# Value Planning Report

## Plan Formulation Project South Utah & Juab County, UT

Workshop Dates: June 24-28, 2024  
Report Date: October 29, 2024

Final  
Value Engineering Study Report  
for

Alternative No.: MC-07

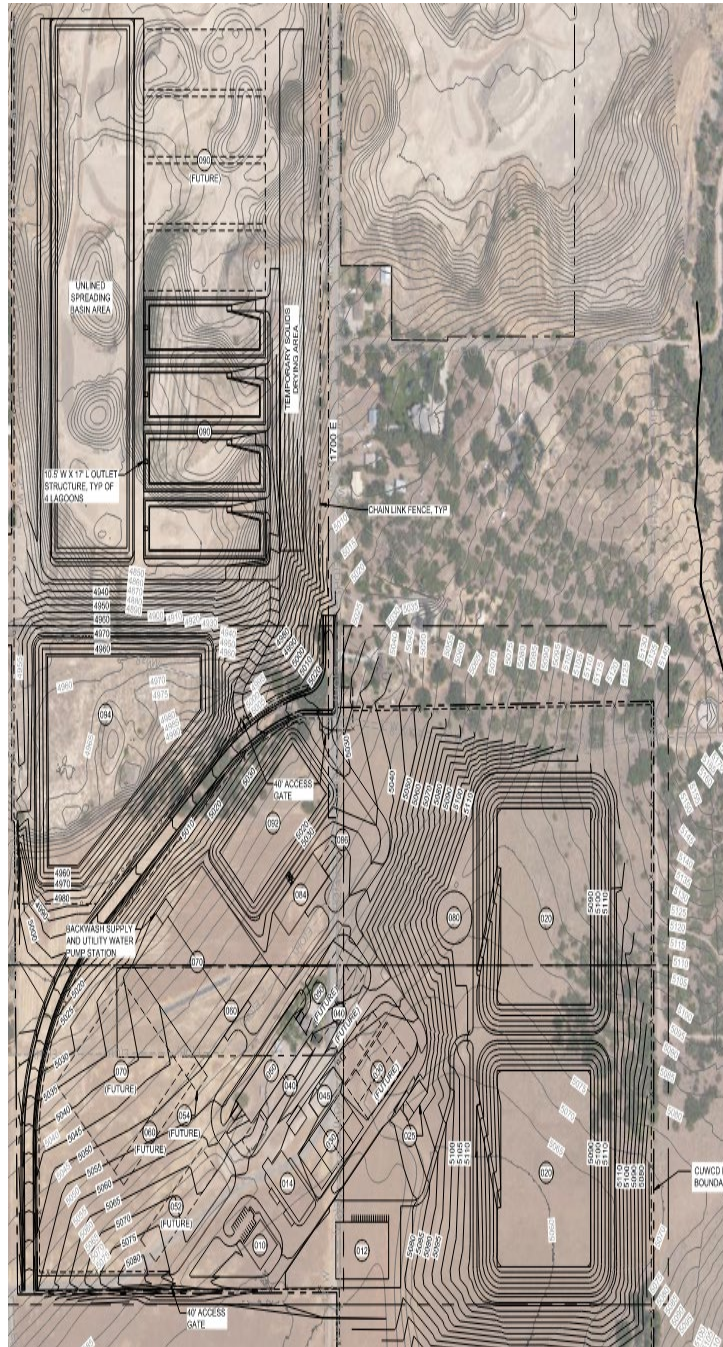
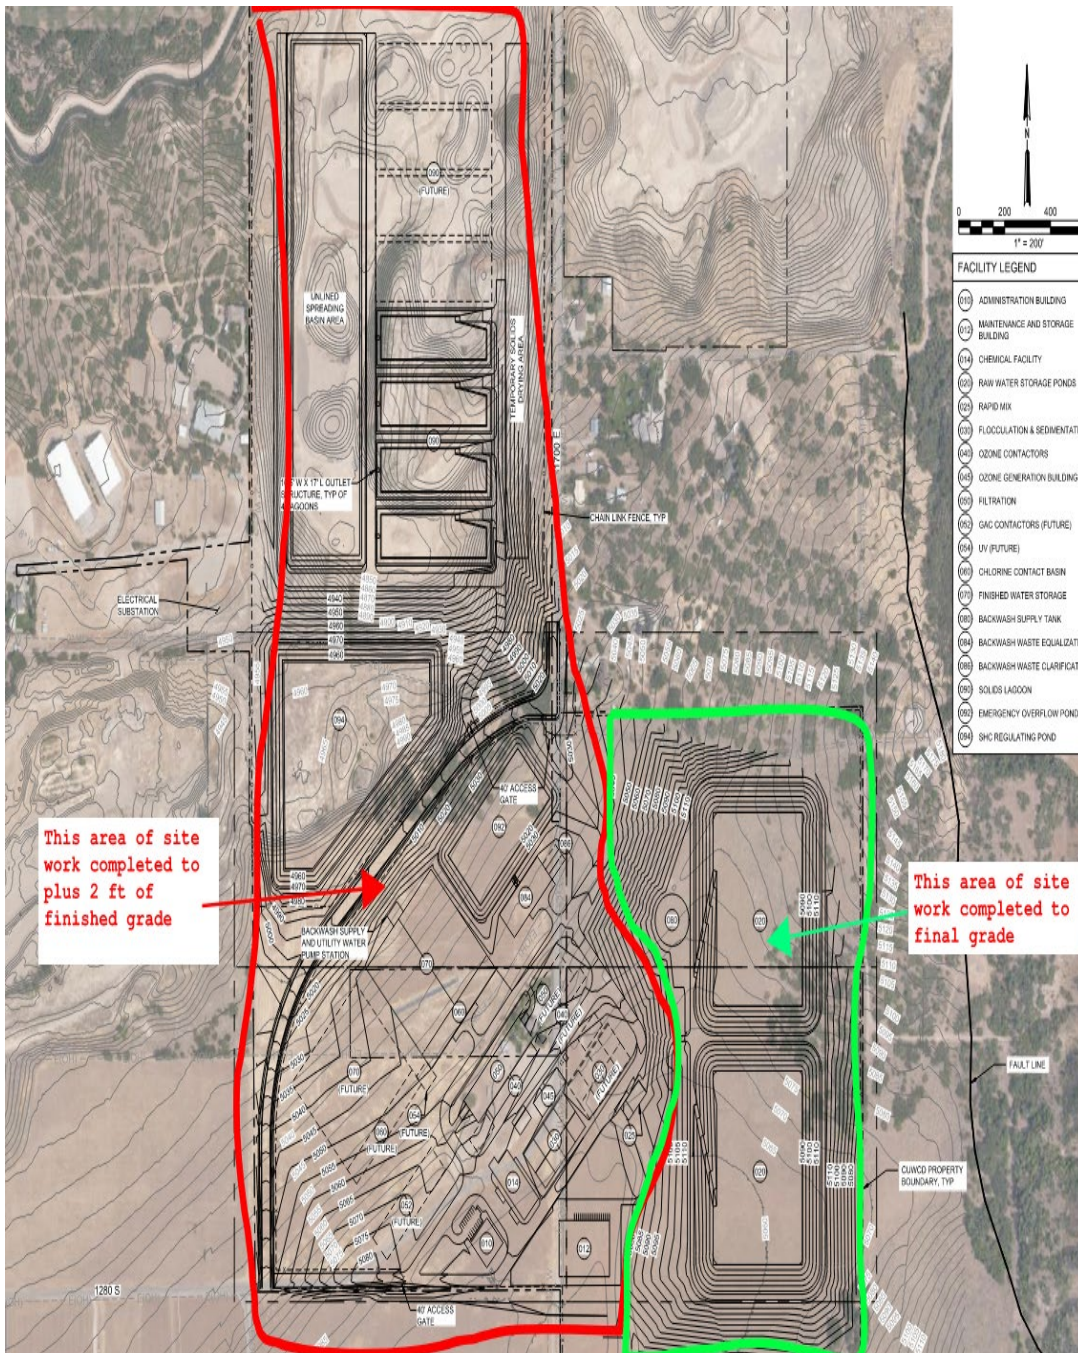
MC-07  
Bid the South Utah Valley Regional Water Treatment Plant as two packages - one for civil works and one for water treatment plant construction ..... 6-31

Hire a designer to design and develop project documents for the site work including the construction of the two 50 MG raw water storage ponds. Advertise and bid on these as a standalone package while WTP plans are being finalized. Include statements in the contract about coordinating with the WTP contractor when they are selected.

Assume a 12 MO earlier start for civil site work package which could provide an overall earlier completion date.

Alternative No.: PW-05

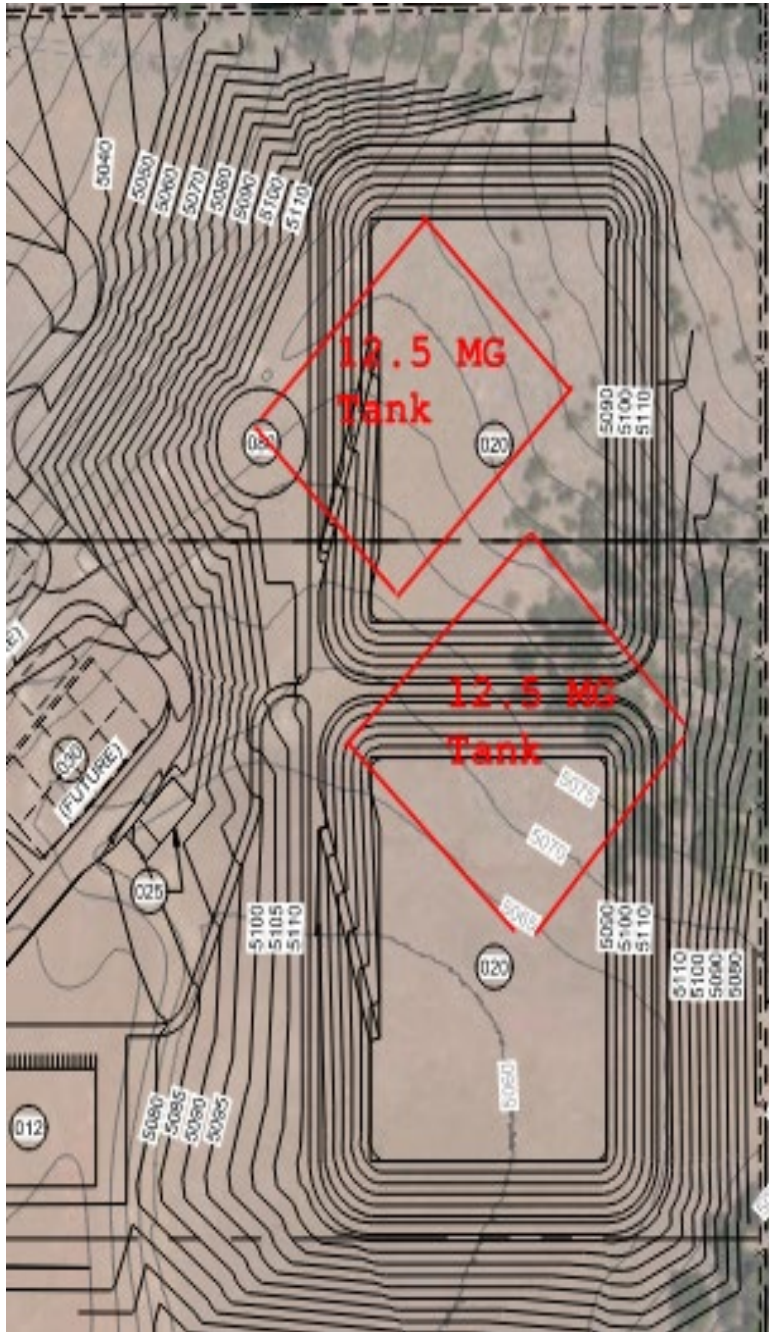
The Value Team believes that the original design of the earthen raw water storage ponds will be subject to the state's dam safety requirements, which is expected to increase the cost and complexity of construction. Additionally, the Value Team is concerned that the Phase 1 buildout of 100 MG of raw water storage may not be necessary if the demand stays on the low end of the projections as per Figure 1-3 in the Plan Formulation Phase II Final Report.

To implement this idea, the design criteria for the concrete cast-in-place tanks will need to be established. Also, a design will need to be developed for both the raw water and finish water tanks to be the exact same size and dimensions, such that contractor can use the same exact forming system for both sets of tanks.

Alternative No.: PW-07

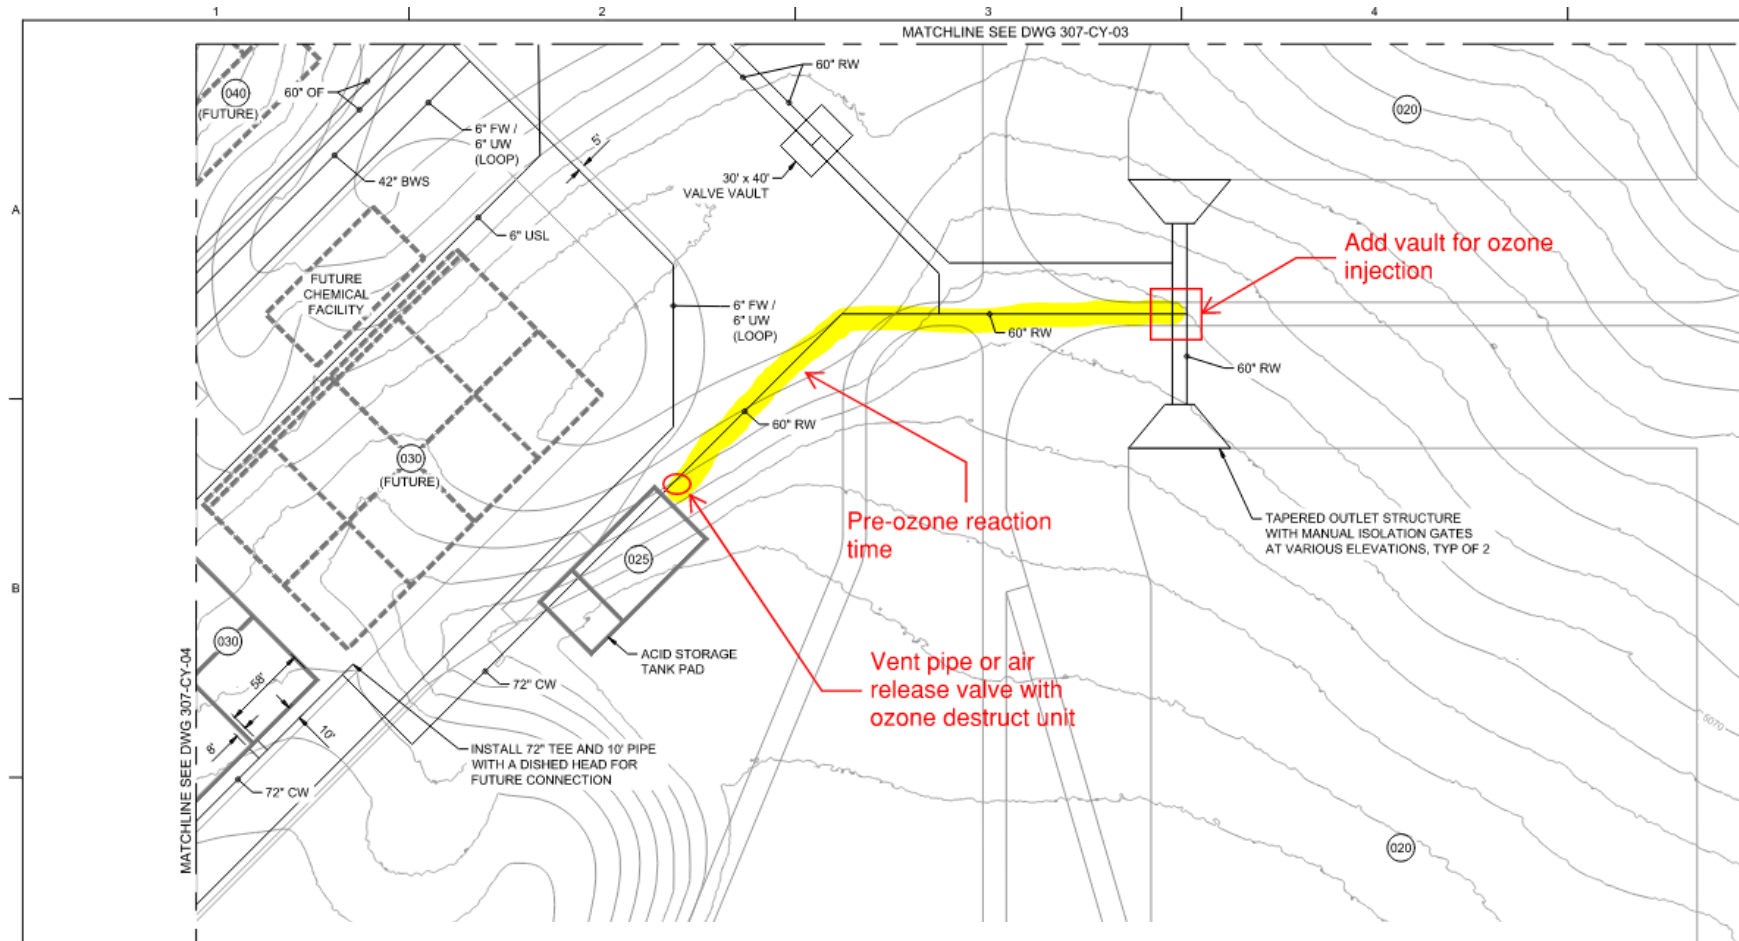
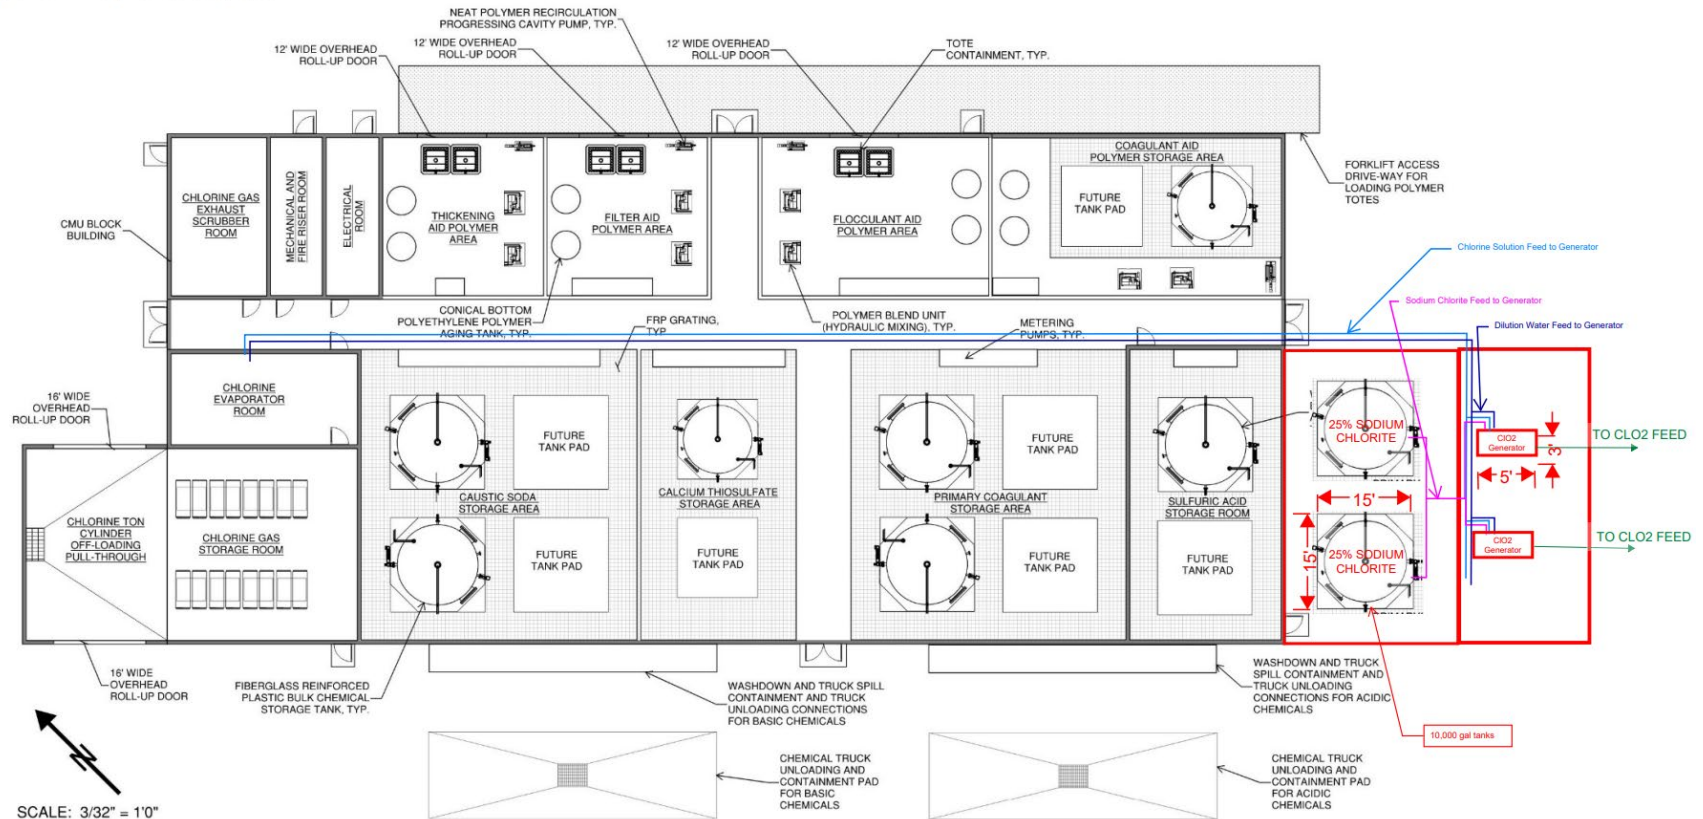
1. Collection of data on the seasonality of manganese concentrations in the source water.
2. Evaluation and implementation of options for decreasing manganese concentrations in the source water reservoir.
3. Pilot testing of the two alternate oxidants, pre-ozone and chlorine dioxide.
4. Selection of the treatment approach and incorporation into design.

Alternative No.: PW-09

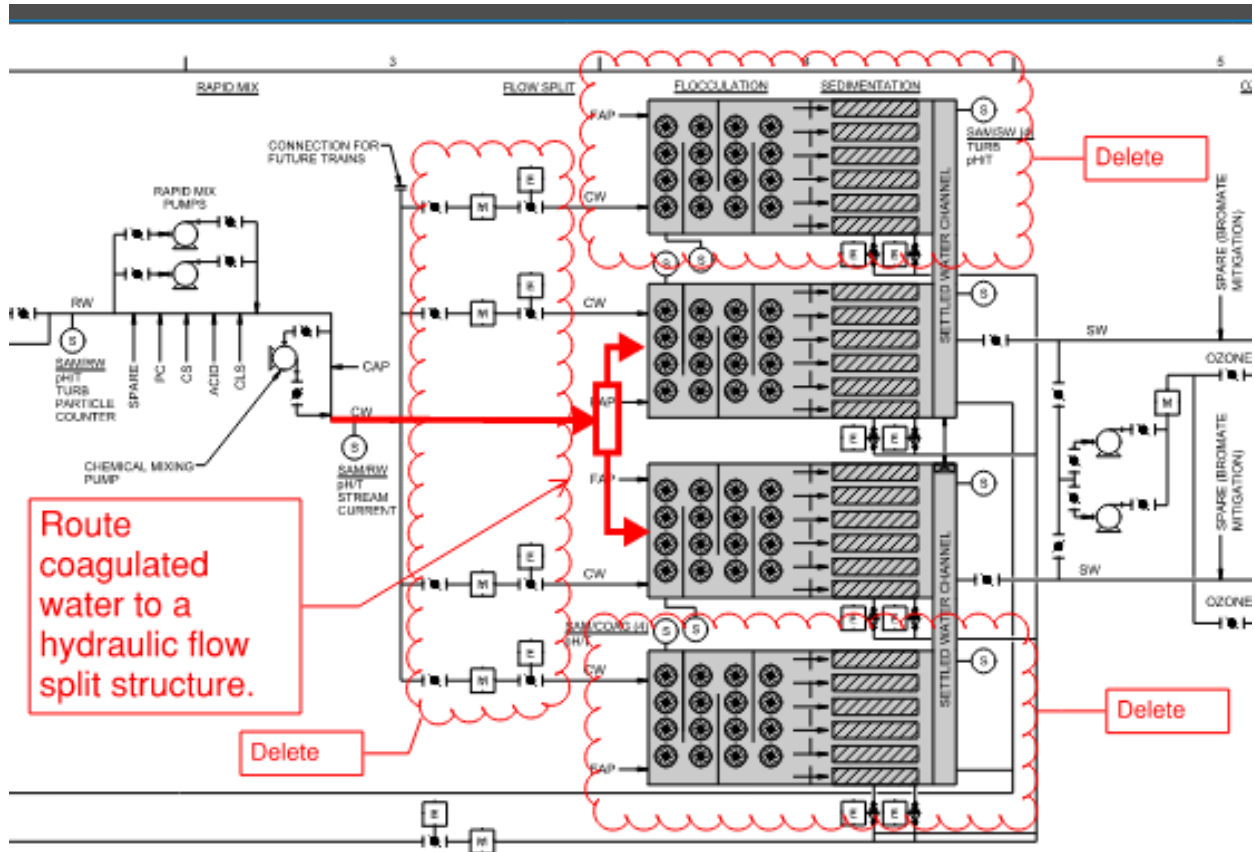
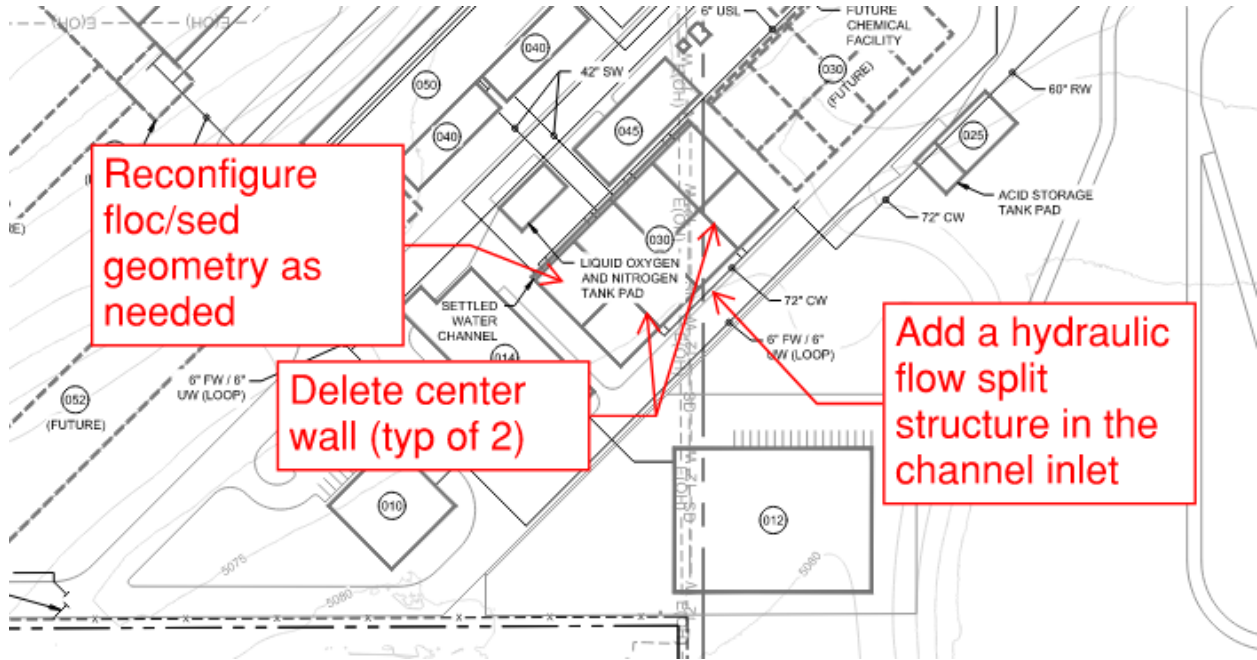
The Point of the Mountain WTP is a 75 MGD basin with three 25 MGD floc/sed trains with plate settlers. The Value Team believes a 25 MGD is a reasonable size for a WTP.

**Configuration Reduces the Number of Floc/Sed Basins from Four to Two**
